# UNITED STATES PATENT AND TRADEMARK OFFICE

10/534,672

MIRABEAU, MONIQUE A

## **DETAILED ACTION**

Fig. 1

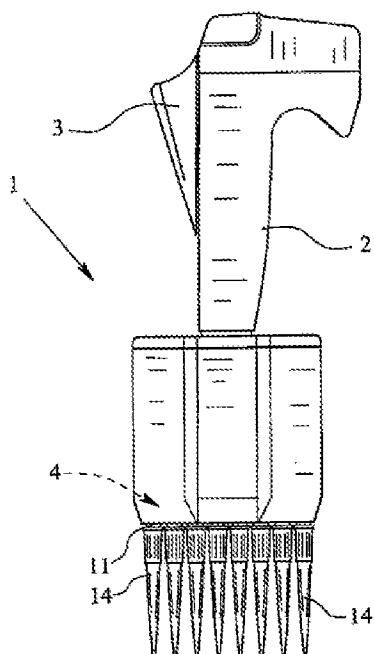
9. With respect to claim **1**, **WANNER** teaches a multiple channel pipetting device. **WANNER** discloses a multiple channel pipetting device (figure 1) (pipetting arrangement) that includes a shaft carrier (4, see figure 1) (carrier) to which first ends of the plurality of mutually parallel tip holder (13, see figure 2a) (nozzles), where the tip holder (13) (nozzles) are spaced only a slight distance apart, wherein second ends of the tip holder (13) (nozzles) are designed to carry a readily replaced pipetting tip (par. 0023, lines 5-6), and where the multiple channel pipetting device (figure 1) (pipetting arrangement) also includes means for establishing at the second end of a respective tip holder (13) (nozzle) a selective pipette plunger (7) (pressure for sucking fluid into and dispensing fluid from the times/tips).

Fig. 2a

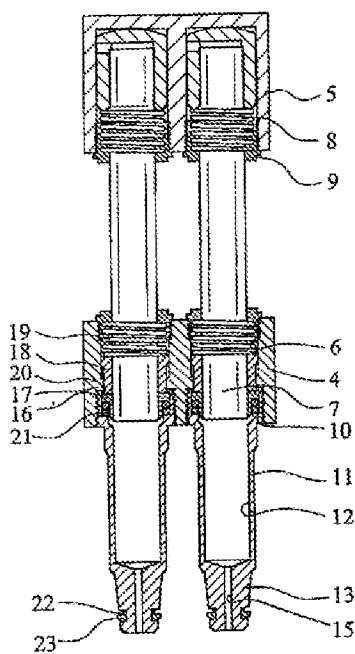
32. With respect to claim **5**, **WANNER** as modified by **PUCHINGER et al.** teaches a multiple channel pipetting device which carries a elastomer ring, in particular O-ring (**WANNER**, 21, fig. 2a) (par. 0032, lines 8) (sealing ring) which seals against the inner circumference of the pipette tip (14) (pipetting tip).

Fig. 8

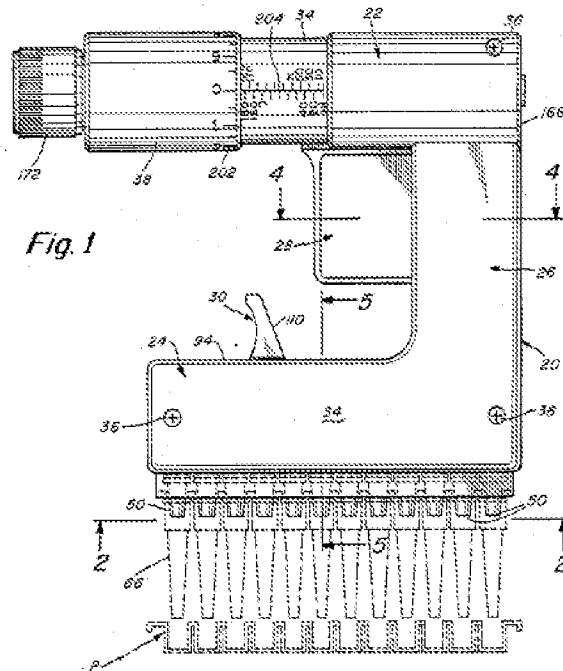
11. However, **PUCHINGER et al.** teaches a pipetting device comprising a retaining cone for holding a slip-on pipette tip and pipette tip for such pipetting device. PUCHINGER et al. discloses a pipetting device (pipetting arrangement) that includes a body (2, fig. 8) (carrier) to which first ends of the parallel nozzles (54, fig. 2) are connected with the aid of respective screw threaded joints (41) (screw joints), where the second ends of the nozzles (54) are designed to carry a slipped on (readily replaced) (col. 8, line 61) pipette tip (10) (pipetting tip). The turning tool for respectively tightening and loosening the screw joint is not physically a part of the claimed device. The prior art is capable of performing the structure and function of the apparatus of the applicant.

Fig. 2

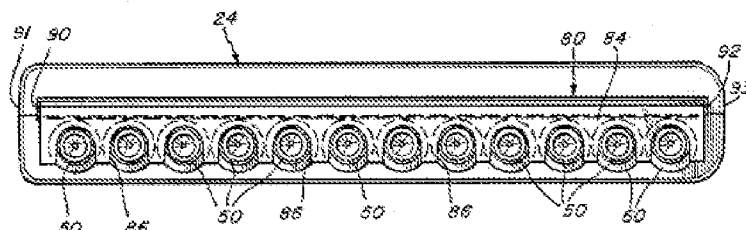
20. With respect to claim **2**, **WANNER** as modified by **PUCHINGER et al.** does not teach the groove. However, **LYMAN et al.** teaches a multi-channel pipetter. **LYMAN et al.** discloses a multi-channel pipetter (arrangement) the driving formation includes a slot (86) (groove) (col. 4, lines 5-7) on the free end of the tip holder (50) (nozzle) in the axial plane (figure 2). The presently claimed tool which includes a blade that co-acts with the groove is not physically apart or intended to be used with the device. Further prior art is

25. With respect to claim 3, **WANNER** as modified by **PUCHINGER et al.** and **LYMAN et al.** **LYMAN et al.** discloses a multi-channel pipetter (arrangement) that the driving formation is a slot (86) (groove) (col. 4, lines 5-7) which is centered with respect to the axis of the tip holders (50) (nozzle) (figure 2). The tool includes a cross-headed blade for co-action with the cross-shaped groove.

**Fig. 13**

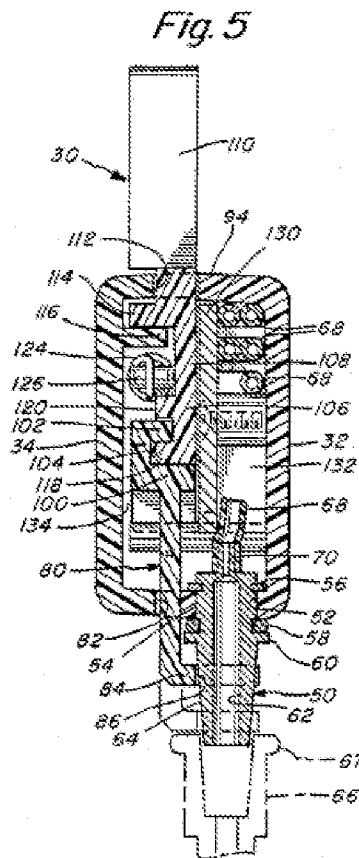
27. However, **EIHUSEN et al.** teaches a pressure washer comprising a cruciform groove (77, fig. 13) (cross-shaped groove). It would have been obvious to substitute.

28. At the time of the invention, it would have been obvious to one of ordinary skill in the art to modify the multiple channel pipetting device of **WANNER** as modified by **PUCHINGER et al.** and **LYMAN et al.** to include the cruciform groove (cross-shaped groove) of **EIHUSEN et al.** The prior art is capable of performing the structure and function of the apparatus of the applicant. The tool does not further limit the device, and it would be obvious to one of ordinary skill in the art to use a screwdriver to tighten or loosen the screw joint (see MPEP 2112).
